CHANGE ORDER NUMBER: 1HNTB Corporation
Round Rock

Project:	<u>1811-278</u>
Roadway:	<u>Forest North-Anderson Mill</u>
CSJ Number:

**Forest North-Anderson Mill
Williamson County Project No. 1811-278**

Change Order No. 1

#3

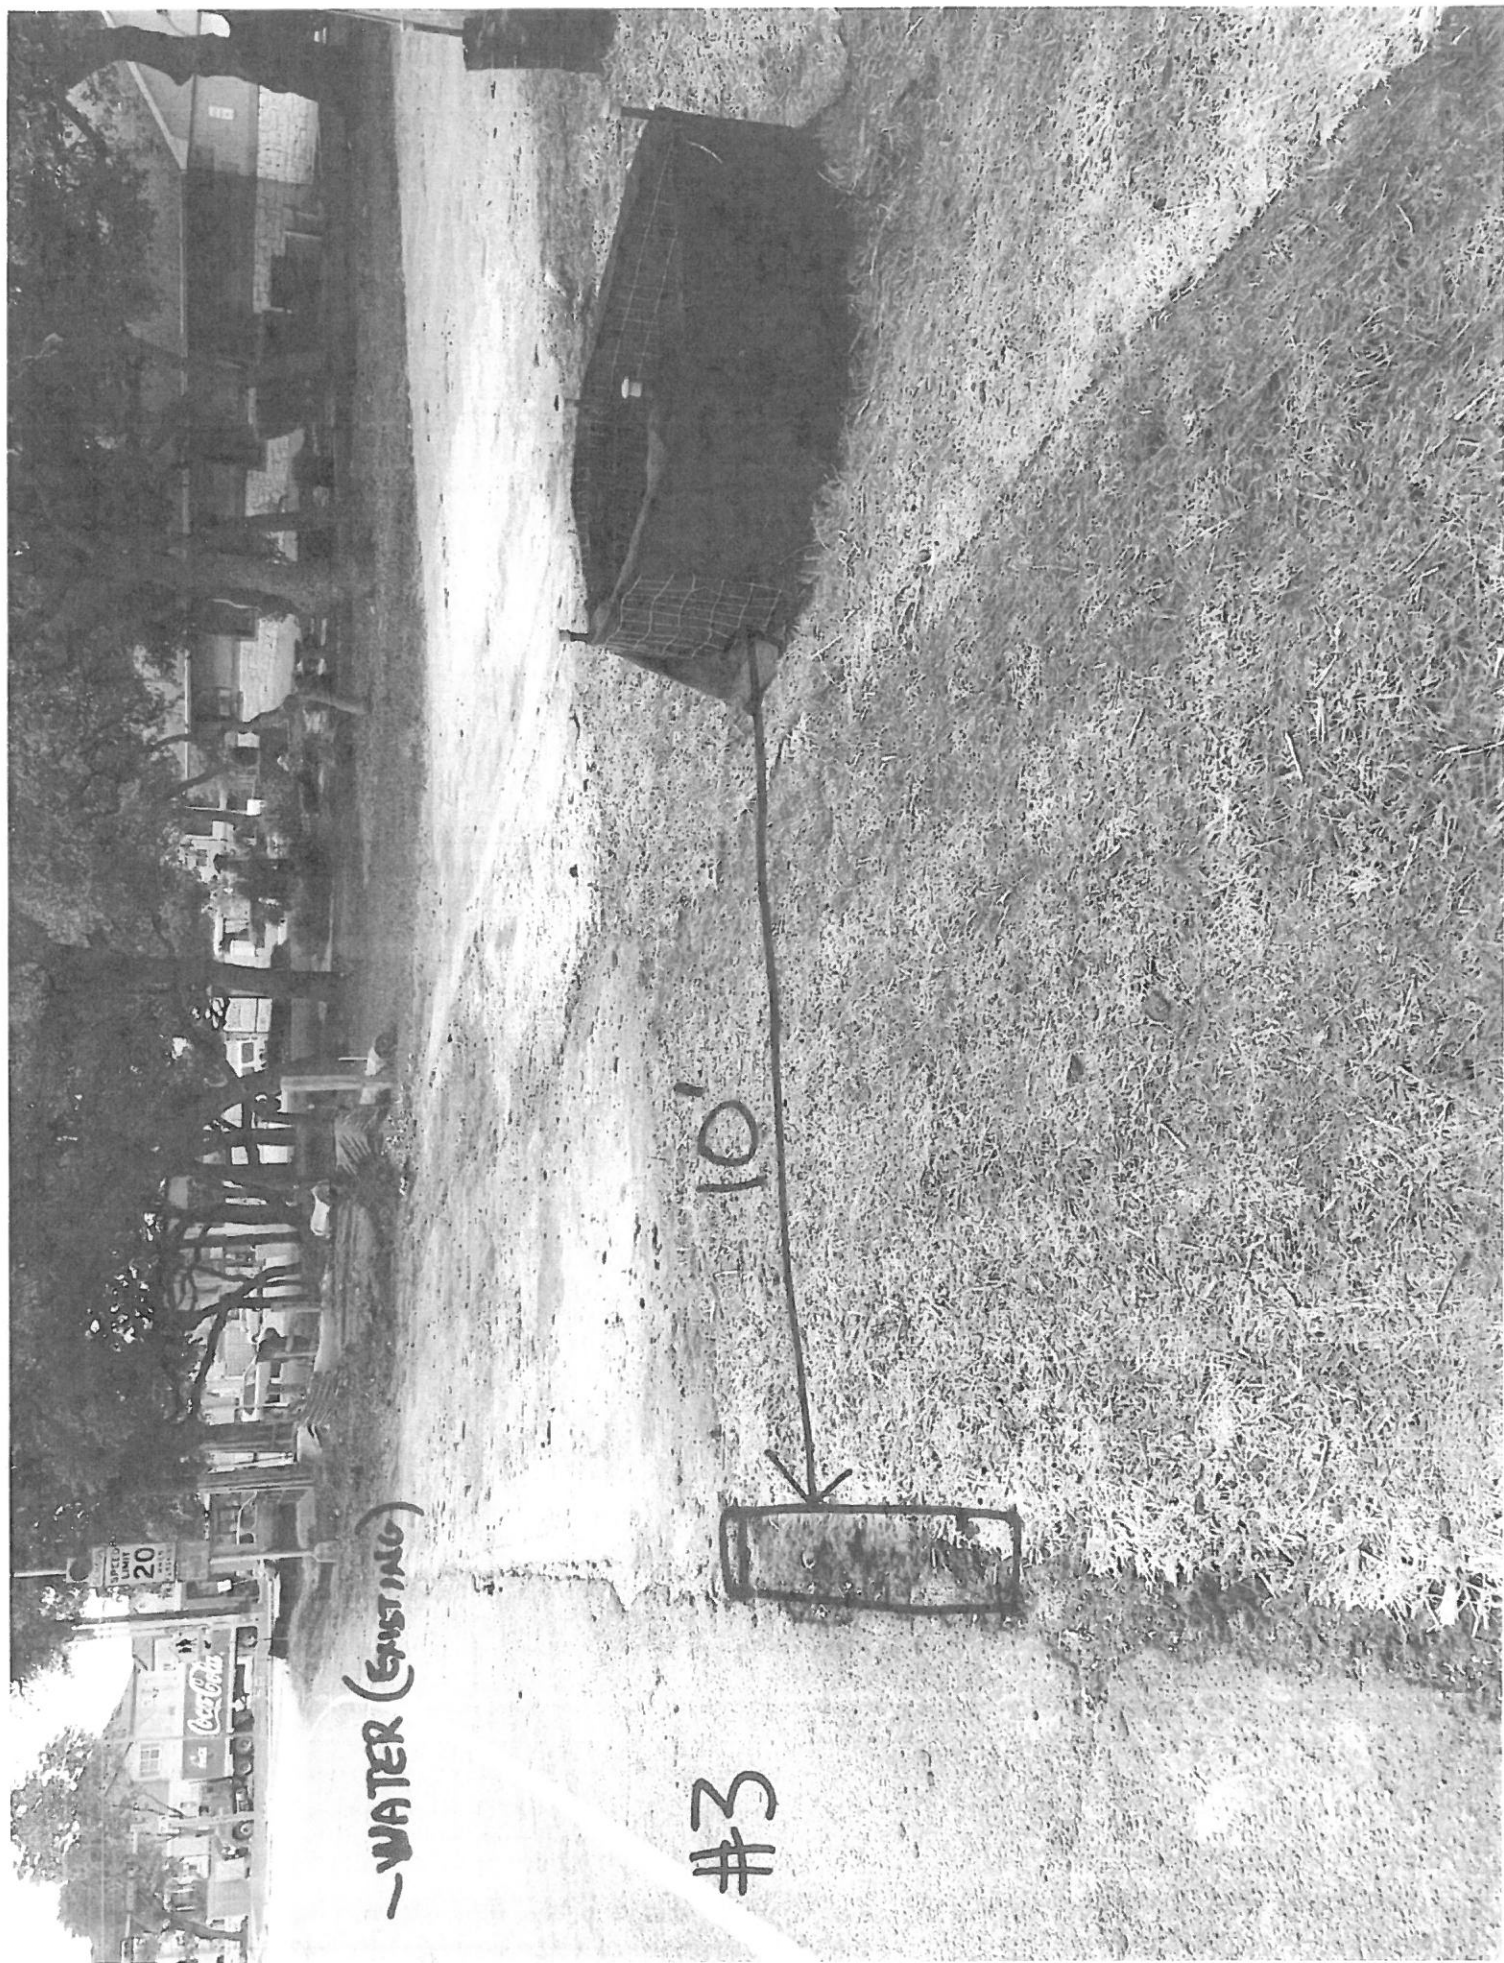
Pothole 3: Waterline, Broadmeade and Roxboroough, between costumers driveways

Trench: 3'x4'x5'
T.O.P: 922.20
B.O.P: 921.50

AWU agrees that the lines are determined to not be in conflict and so can be removed from the scope of the project.

#4

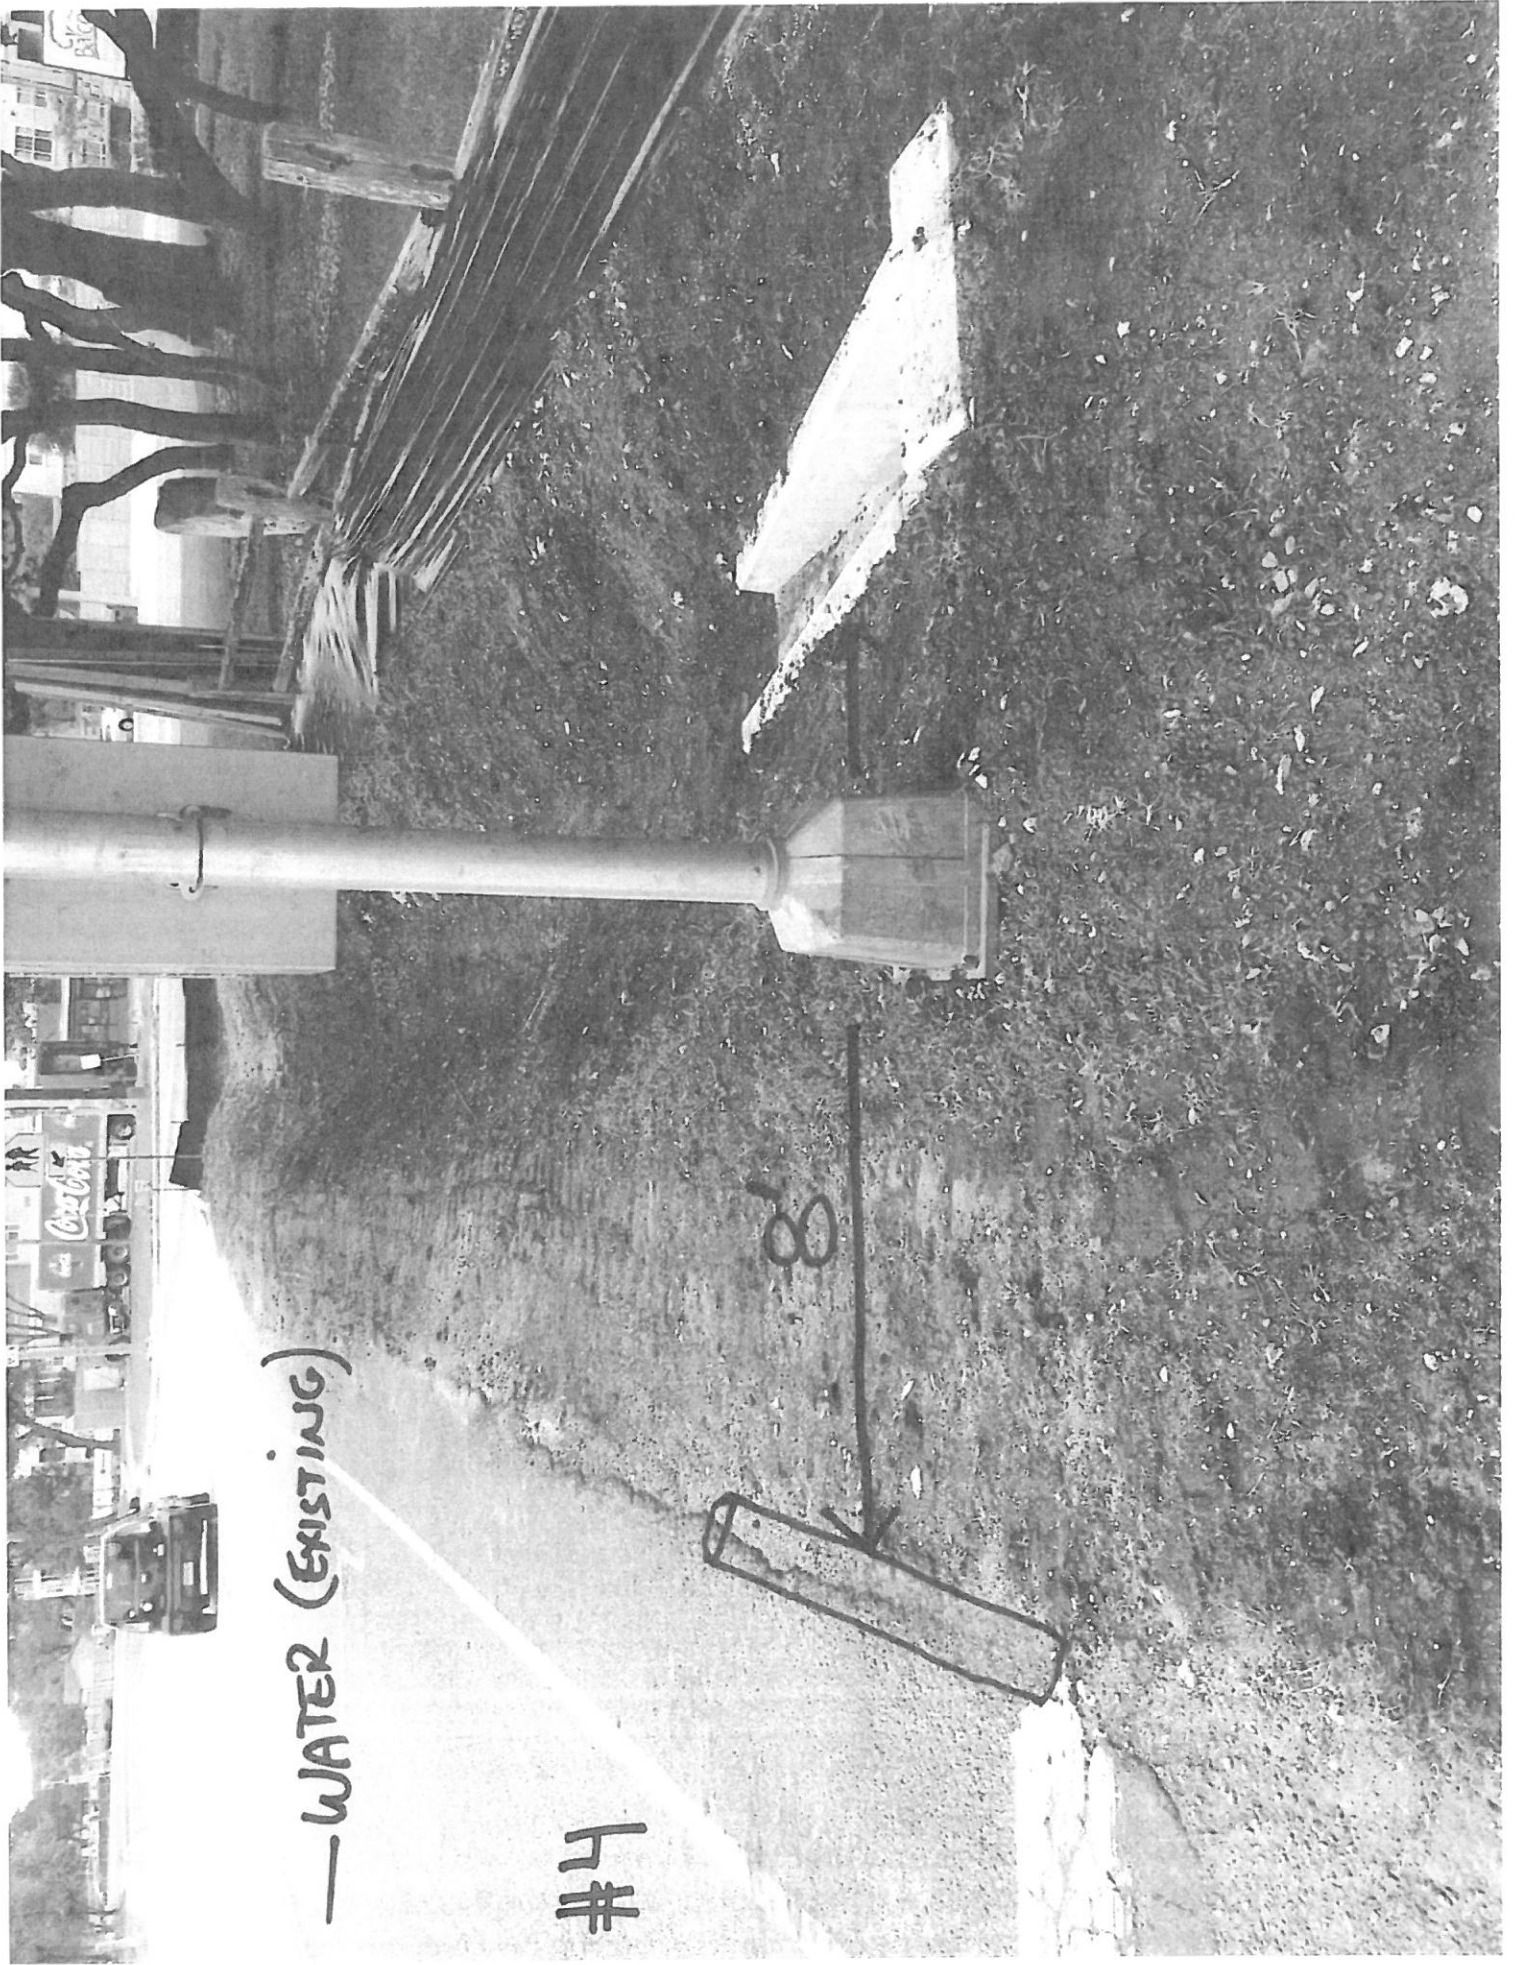
Pothole 4: Waterline, Dentist office between fence and Asphalt

Trench: 5'x4'x4'
T.O.P: 922.15
B.O.P: 921.45
